# Heavy Vehicle Local Road Report Parramatta

<b>Project Name:</b>	Sydney Metro West		
<b>Client Name:</b>	Sydney Metro		
<b>Project Address:</b>	DELTA will be working at the following sites: 1. Parramatta 2. Clyde 3. Westmead		
<b>Project Description/Scope:</b>	DELTA Pty Ltd (DELTA) is responsible for the demolition of existing structures including removal of all hazardous materials and utility works of the Sydney Metro West Project at Clyde, Parramatta and Westmead		
<b>Prepared By:</b>	Name: [Redacted]	Signature: [Redacted]	Date: 7 <sup>th</sup> October 2021
<b>Reviewed By:</b>	Name: [Redacted]	Signature: [Redacted]	Date: 7 <sup>th</sup> October 2021
<b>Authorised By (Project Director):</b>	Name: [Redacted]	Signature: [Redacted]	Date: 7 <sup>th</sup> October 2021

Project	SSI 10038 – Sydney Metro West
Document	10038-PA-47 – Heavy Vehicle Local Road Report Parramatta – Rev 2, dated sept 22 2021
Date received from Sydney Metro	Sept 22 2021
Date comments sent to Sydney Metro	Sept 29 2021

**Figure 8: Land use - Parramatta (source: Chapter 14 Property and Land Use EIS)**

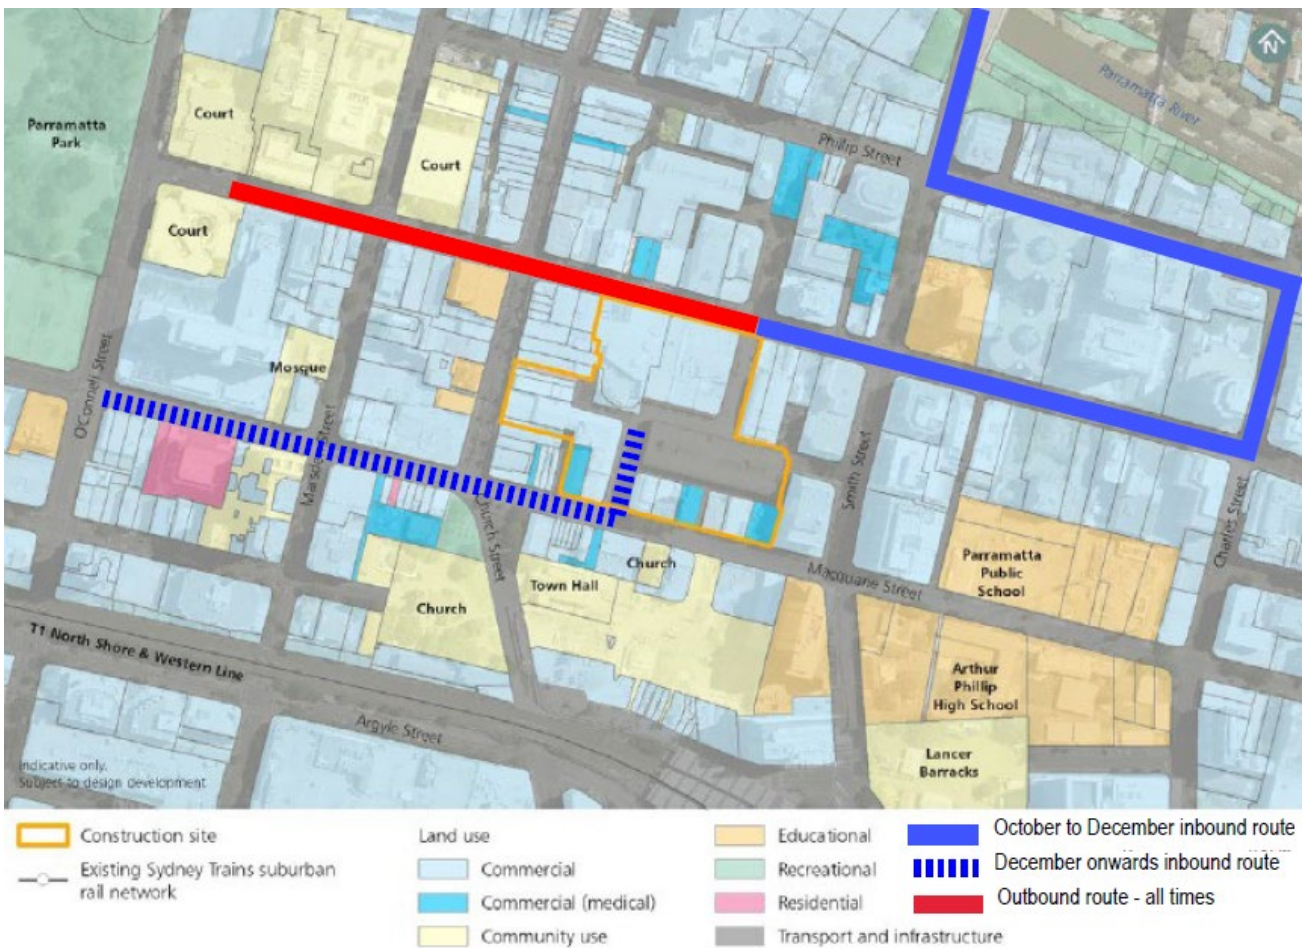
24.01.01	22/09/2021	SMD					Yes, the map shows existing conditions, the route proposed goes past that (and other) existing conditions. For example one of the existing conditions is Western Sydney University. Does the route proposed have an impact on students and the University? If so, what are the mitigation? That is what is required by DPIE.	Minor Non-Compliance	N
											There is no impact to Western Sydney University as it is located on Smith Street between Phillip Street and George Street which is not part of the proposed heavy vehicle route	Minor Non-Compliance	N
				37	17/09/2021	HBI		SMWSDDS-DLT-PTA-TF-REP-000059	Heavy Vehicle Local Road Report - Table 1	D87	Table 1: Ministerial Conditions of Approval requirements for HVLRMcoA D83 relevant to HV is not addressed in this Table and document. Review/update accordingly.	Actual Non-Compliance	N
								SMWSDDS-DLT-PTA-TF-REP-000059	Heavy Vehicle Local Road Report - Table 1	D87	Not applicable - refer to Schedule 20 from Sydney Metro	Actual Non-Compliance	N

24.01	20/09/2021	DLT		SMWSDDS-DLT-PTA-TF-REP-000059	Figure 8	General Specification	This section is describing Existing Conditions. As noted in the report there is no other available routes- refer to Section 8	Minor Non-Compliance	N
								SMWSDDS-DLT-PTA-TF-REP-000059	Figure 8	General Specification	Figure updated	Minor Non-Compliance	N

**Figure 20: Post Christmas proposed inbound route (indicative site boundary only)**

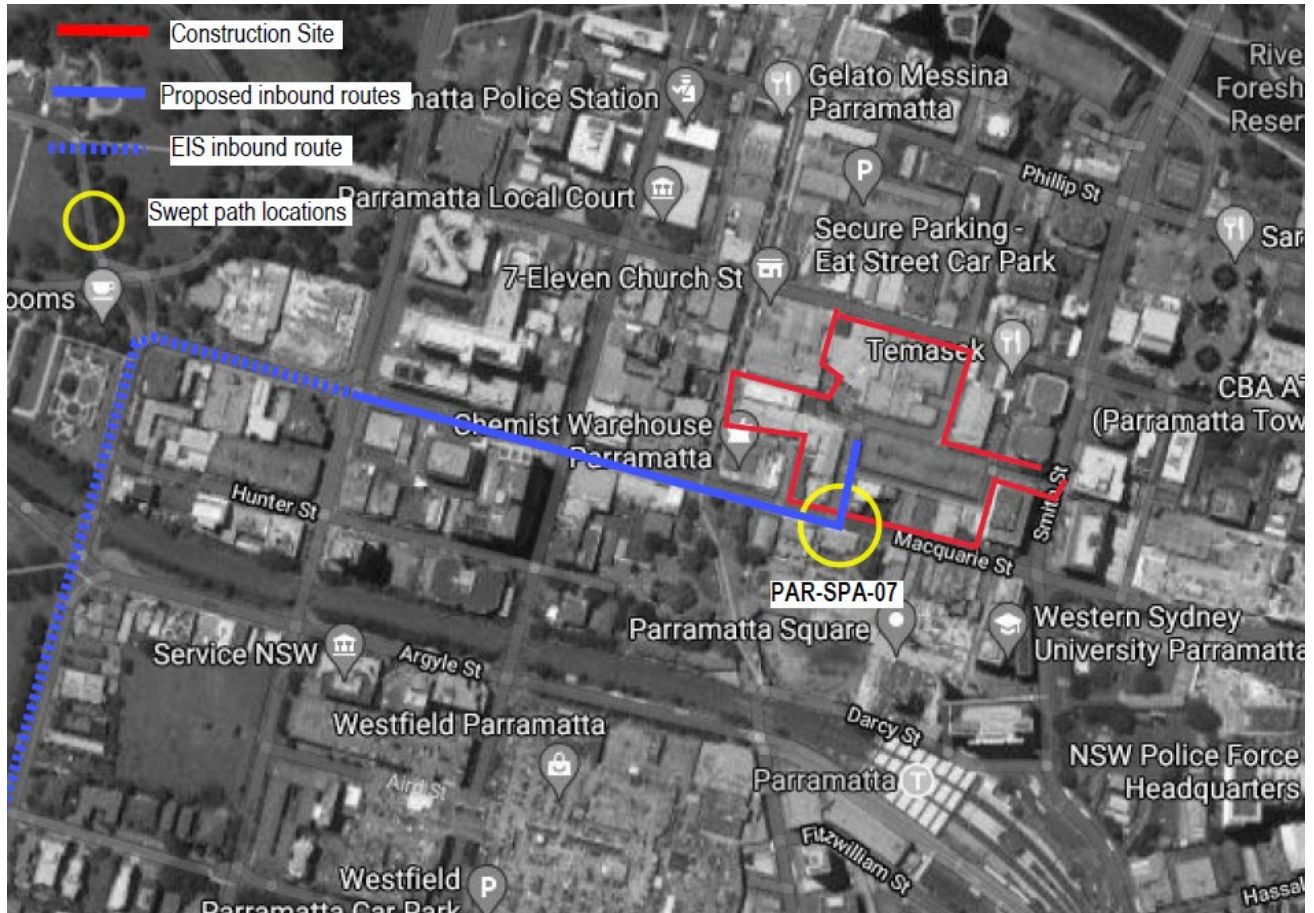
[REDACTED]	SMWSDDS-DLT-PTA-TF-REP-000059	Figure 17	2.11.1 (f) of the General Specification	This is the route provided by Sydney Metro as part of the Demolition contract award. The initial route (Sept to Dec) is a compromise route to allow all works as noted in section 8.2 and as noted in section 8.3. Pedestrians will be maintained on the southern footpath of Macquarie Street only removing the interface between vehicles and pedestrians at the intersection of Horwood Place and Macquarie Street	Minor Non-Compliance	N

DOCUMENT NO.	TITLE	VER	STATUS	NO.	DATE	COMPANY	RAISED BY	REVIEW DOC. NO.*	DOCUMENT REF*	DEED REF*	COMMENTS / RESPONSE	COMMENT CATEGORY*	CLOSED OUT
				12.01.01	23/09/2021	TFN					Response noted - will adjust to minor non compliance as there are still requirements to consider safety risks and how they will be minimised through such a highly pedestrianised area. If Sydney Metro can't provide this analysis and risk assessment when the route was decided on then please consider the risks and demonstrate what controls will be implemented along Macquarie Place to reduce the risk to other road users, especially pedestrians. Example controls may include instructions to drivers not to queue across intersections (Church and Macquarie), spotters or traffic controllers managing pedestrians while vehicles turn into Horwood Place, and additional safety messaging and awareness for pedestrians on the presence of heavy vehicles in the form of pavement decals at either side of Horwood Place.	Minor Non-Compliance	N

12.01	20/09/2021	DLT	[REDACTED]	SMWSDDS-DLT-PTA-TF-REP-000059	Figure 17	2.11.1 (f) of the General Specification	This is the route provided by Sydney Metro as part of the Demolition contract award. The initial route (Sept to Dec) is a compromise route to allow all works as noted in section 8.2 and as noted in section 8.3	Minor Non-Compliance	N
							[REDACTED]	SMWSDDS-DLT-PTA-TF-REP-000059	Figure 17	2.11.1 (f) of the General Specification	This is the route provided by Sydney Metro as part of the Demolition contract award. The initial route (Sept to Dec) is a compromise route to allow all works as noted in section 8.2 and as noted in section 8.3. Pedestrians will be maintained on the southern footpath of Macquarie Street only removing the interface between vehicles and pedestrians at the intersection of Horwood Place and Macquarie Street	Minor Non-Compliance	N
